Docket Item #
BAR CASE # 2008-0158 and
2008-0159

City Council
May 16, 2009

ISSUE: Appeal of a decision of the Board of Architectural Review, Old and Historic Alexandria District, approving a Permit to Demolish and Certificate of Appropriateness for an addition and alterations

LOCATION: 113 Princess Street

Figure 1 Plan showing proposed first and second level additions

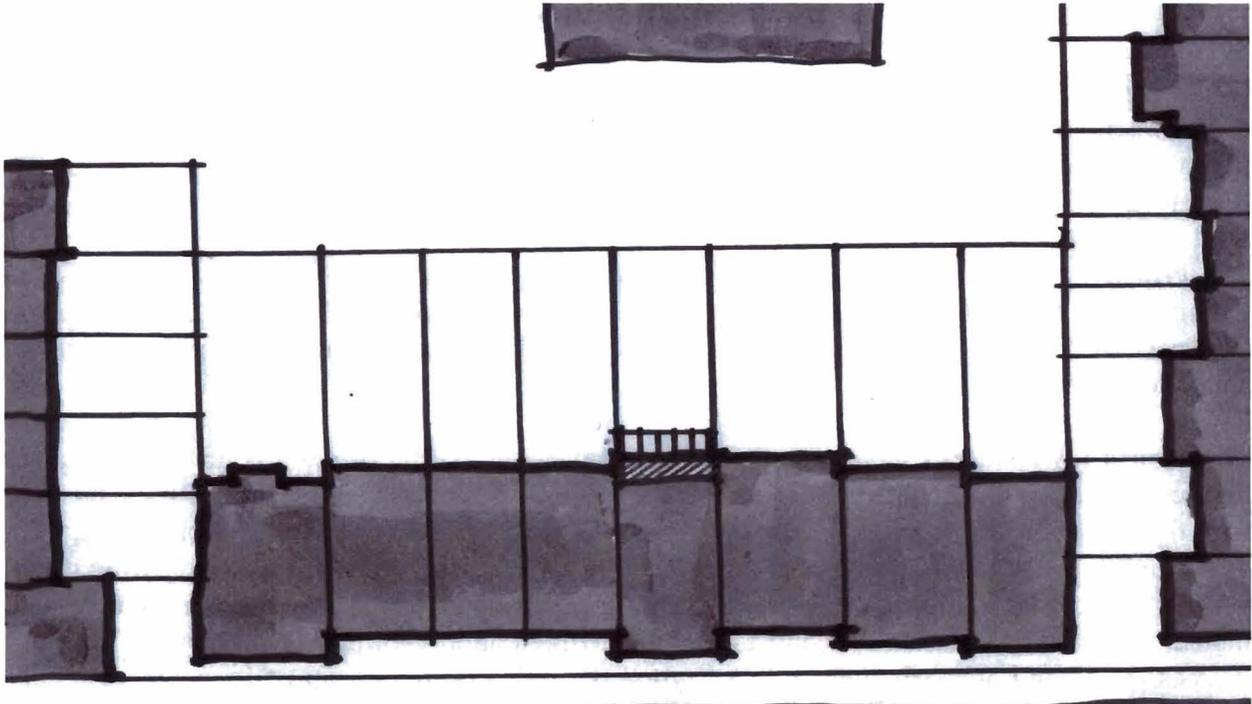
The majority of the addition is on the first floor level and consists of a sunroom with a glass roof. At the second floor, the added structure is a design solution to conceal an elevator shaft. The third floor change is a small extension of the roof to incorporate a shed dormer.

The existing townhouse includes a gross square floor area of 2,544 square feet. The proposed additional gross square floor area is 620 square feet. Both numbers include the basement which is entirely below grade (existing 295 square feet and 192 square feet proposed in the basement addition). In terms of footprint, the addition measures 14 feet by 18 feet at the first story and 6 feet by 18 feet at the second story. The dormer is approximately 13.5 feet in width.

Figure 5. Proposed rear (north) elevation.

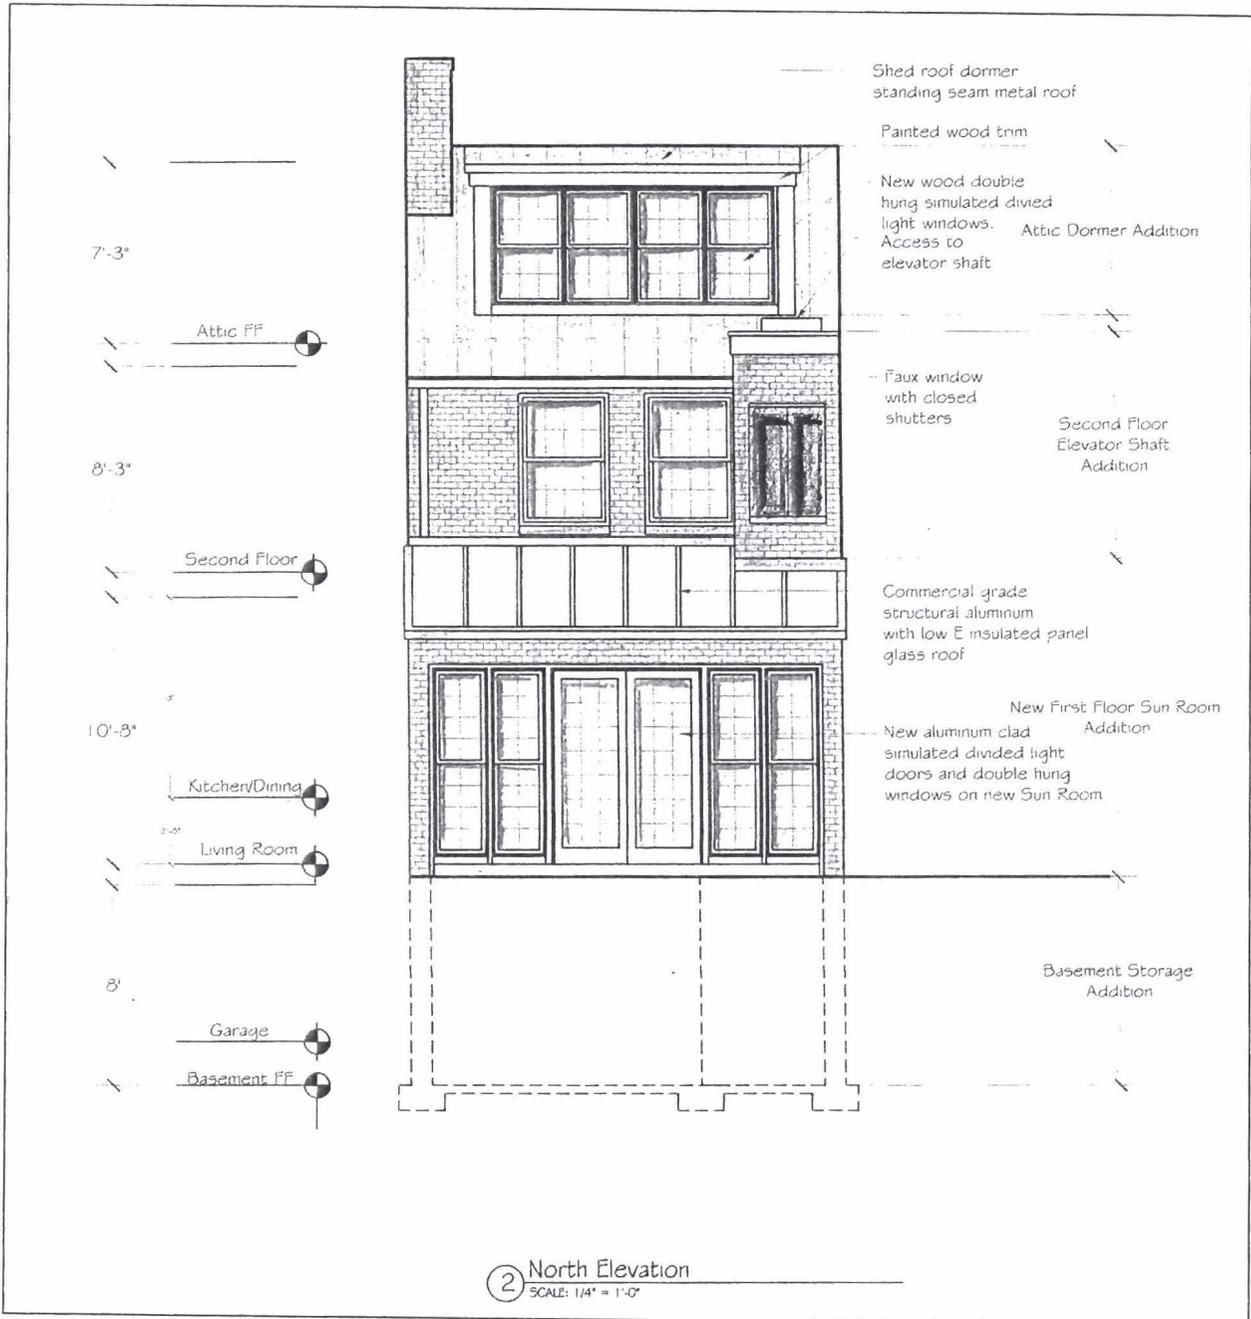
The applicant proposes to replace all the existing windows with six-over-six, simulated divided light wood windows with the exception of the windows on the addition which are proposed to be simulated divided light and aluminum clad.

3. That the windows and doors all be wood; and
4. The statements in archaeology conditions below shall appear in the General Notes of all site plans and on all site plan sheets that involve demolition or ground disturbance (including Basement/Foundation Plans, Demolition, Erosion and Sediment Control, Grading, Landscaping, Utilities, and Sheeting and Shoring) so that on-site contractors are aware of the requirements:

Figure 4. Proposed front (south) elevation with projecting bay window and dormer.

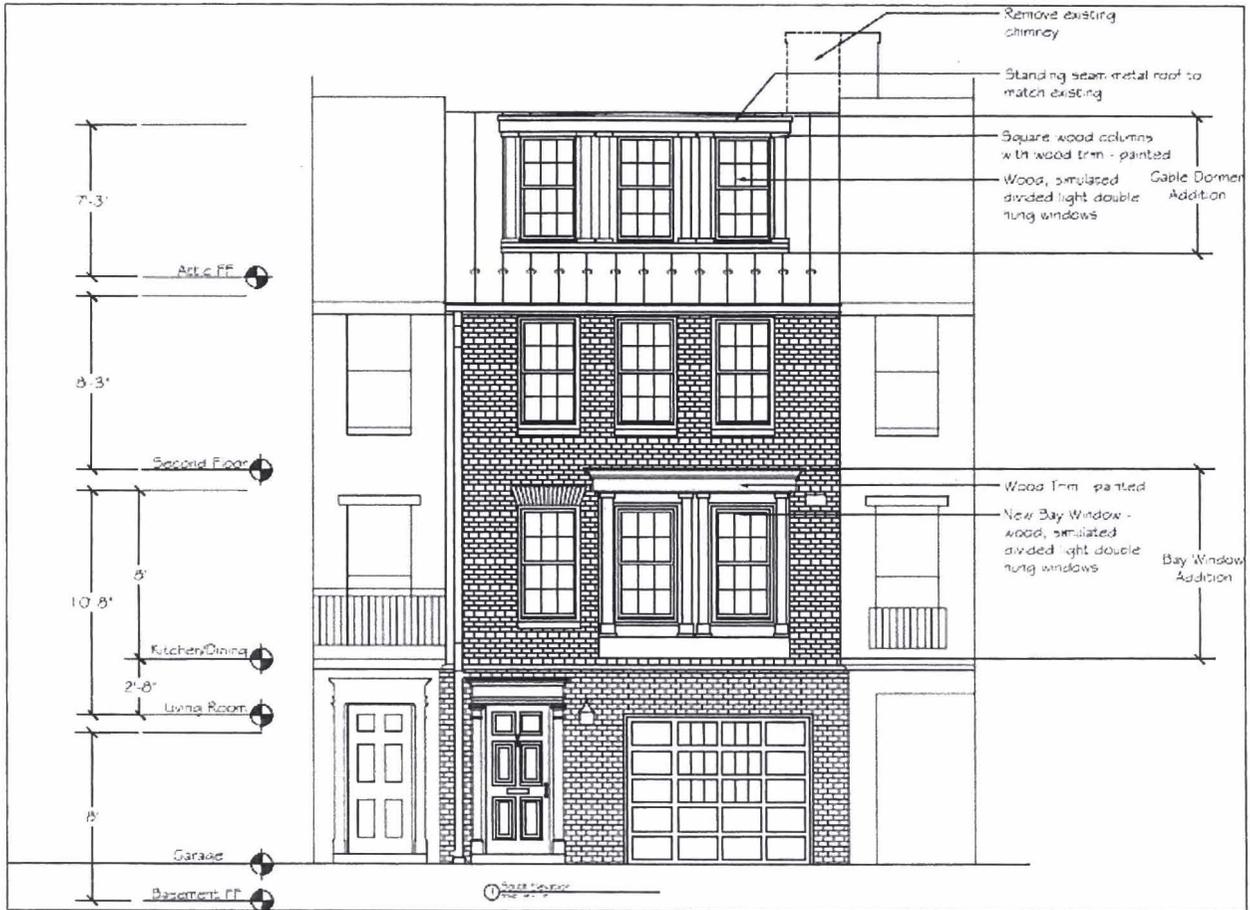
The applicant proposes to install a bay window on the second story where there are currently two single, double-hung windows. The applicant will remove the two single windows and the portion of the brick wall between the window openings. The projecting bay window will be rectangular in plan and feature Colonial Revival detailing. The wood trim will be painted to match the existing trim on the house. The new windows will be six-over-six, simulated divided light, double-hung wood windows.

The applicant is proposing to install a tripartite dormer with flat roof on the existing gable roof of the front elevation. Originally, the applicant had proposed a tripartite dormer with a gable roof and Colonial Revival detailing on the front elevation. The revised dormer is no longer higher than the existing ridgeline. The revised dormer is also Colonial Revival in style with square wood columns. The wood trim and wood columns will be painted to match the existing trim. There will be three six-over-six, simulated divided light, double-hung wood windows. The center window will have a transom as well. The roof will be standing seam metal and will match the existing roof.

Figure 6. Proposed floor plans at basement and first floor.

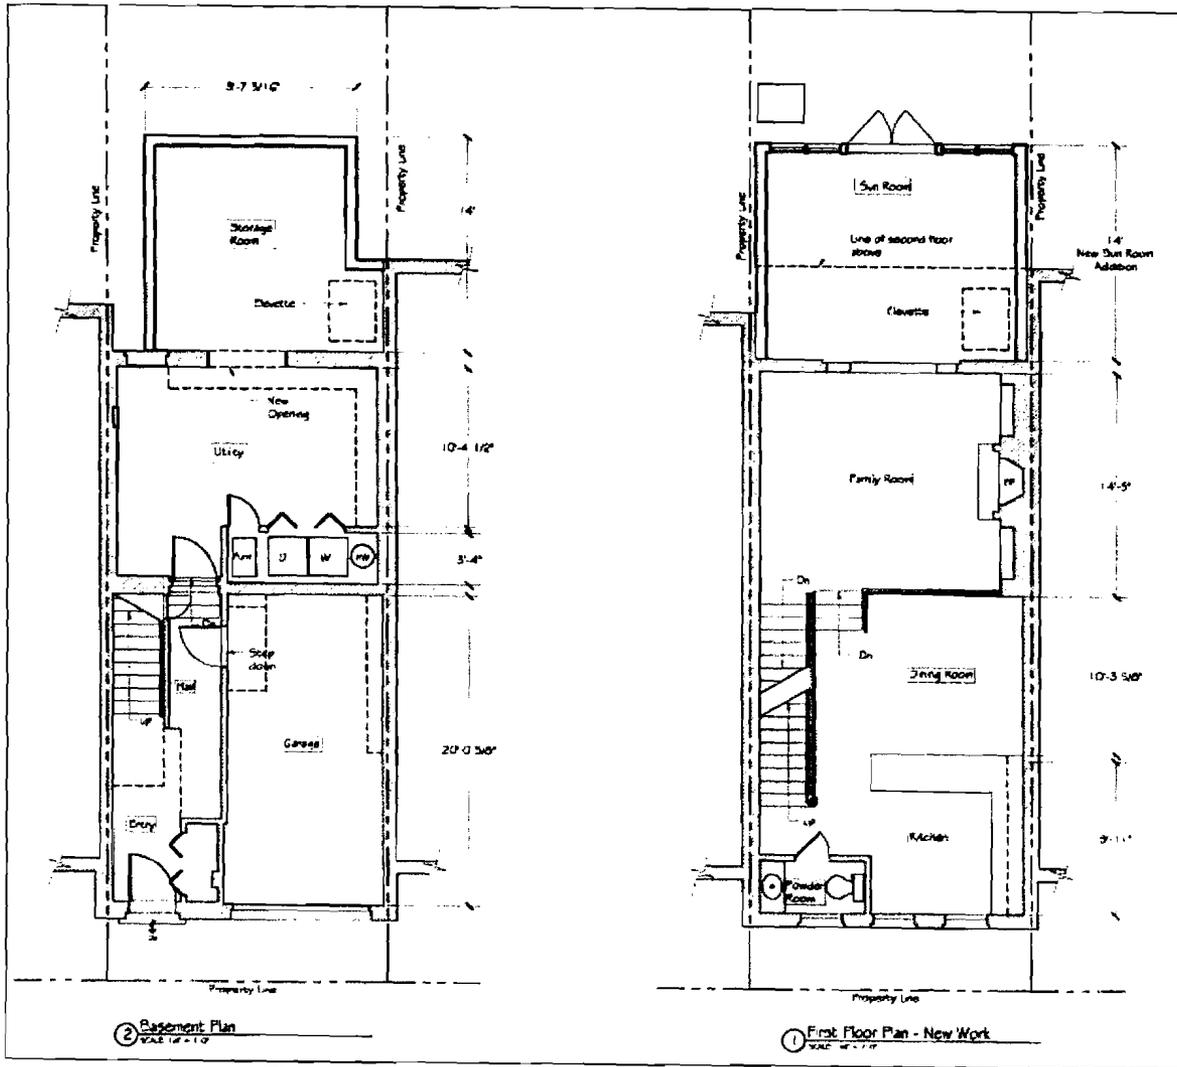
The applicant proposes to replace all the existing windows with simulated divided light wood windows, to match the existing light patterns, with the exception of the windows on the addition which are proposed to be aluminum clad rather than all wood.

5. That the windows and doors be all wood and not aluminum clad; and,
6. The statements in archaeology conditions below shall appear in the General Notes of all site plans and on all site plan sheets that involve demolition or ground disturbance (including Basement/Foundation Plans, Demolition, Erosion and Sediment Control, Grading, Landscaping, Utilities, and Sheeting and Shoring) so that on-site contractors are aware of the requirements:
